Monkton Heathfield Garden Town phase 2 'critical friend' review and next steps suggestions.

July 2020

The Upton Design Code successfully identified streets on different level depending on their role.

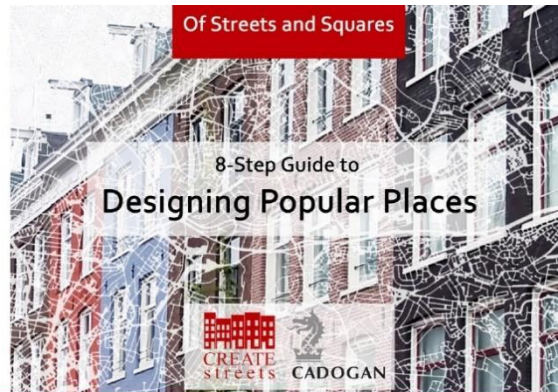
Just as the Design Guidance failed to recognise the smallest streets, so has the Concept Plan. Although most of the infrastructure requirements are highlighted (A38, ERR, Spine Road and secondary routes), no account has been made for tertiary streets. As a result, the block structures fail to offer the level of detail needed to comprehend how exactly they will interconnect.

Gridded or block systems create rich walkable and cyclable systems. If it is the wish to create these formations, then the Concept Plan must offer clearer spatial suggestions for the internal road structure. The lack of clarity on this point, opens up the possibility of a cul-de-sac design that could serve to restrict interconnectivity and sustainable modes of transport.

Suggested action: redraw the Concept Plan to include all street forms (see drawing below).
